Intersection ID: 16828	Main Street: BUCKNELL_AV	Cross Street: SELWYN_AV	Location:	NW
ADA ID: 54BDCE005A8B	Ramp Type: Perp	Initial Pass/Fail: Fail	Overall Compliance: No	Severity Score: 33.75

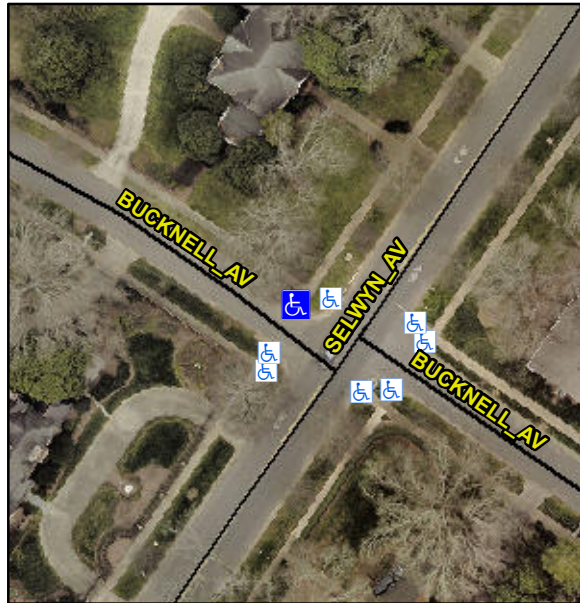
R304.5.1, R304.2.2, R304.5.3

Compliance	Description	Data	Compliance	Description	Data
N/A	Ramp Length (in)	59.0	No	Ramp Slope (%)	9.9
No	Ramp Width (in)	42.0	No	Ramp XSlope (%)	5.4
N/A	Flare Type LT	N/A	N/A	Flare Type RT	N/A
N/A	Flare Slope LT (%)	N/A	N/A	Flare Slope RT (%)	N/A
N/A	Flare Traversable LT?	N/A	N/A	Flare Traversable RT?	N/A
N/A	Landing Length (in)	N/A	N/A	DWS Provided?	N/A
N/A	Landing Width (in)	N/A	N/A	DWS Contrast?	N/A
N/A	Landing Slope (%)	N/A	N/A	DWS Length (in)	N/A
N/A	Landing X Slope (%)	N/A	N/A	DWS Full Width?	N/A
N/A	Landing Curb? (Y/N)	N/A	N/A	DWS Offset (in)	N/A
N/A	Shared Landing?	N/A			
N/A	Gutter Ponding?	N/A	N/A	Gutter Slope (%)	N/A
N/A	Gutter Lip Ht (in)	N/A	N/A	Gutter X Slope (%)	N/A
N/A	Painted X Walk1?	No	N/A	Painted X Walk2?	N/A
	X Walk 1 Direction	To SW		X Walk 2 Direction	N/A
N/A	X Walk 1 Width (in)	N/A	N/A	X Walk 2 Width (in)	N/A
	X Walk 1 Slope (%)	4.9		X Walk 2 Slope (%)	N/A
	X Walk 1 X Slope (%)	1.0		X Walk 2 X Slope (%)	N/A

Remove & Replace Entire Ramp.
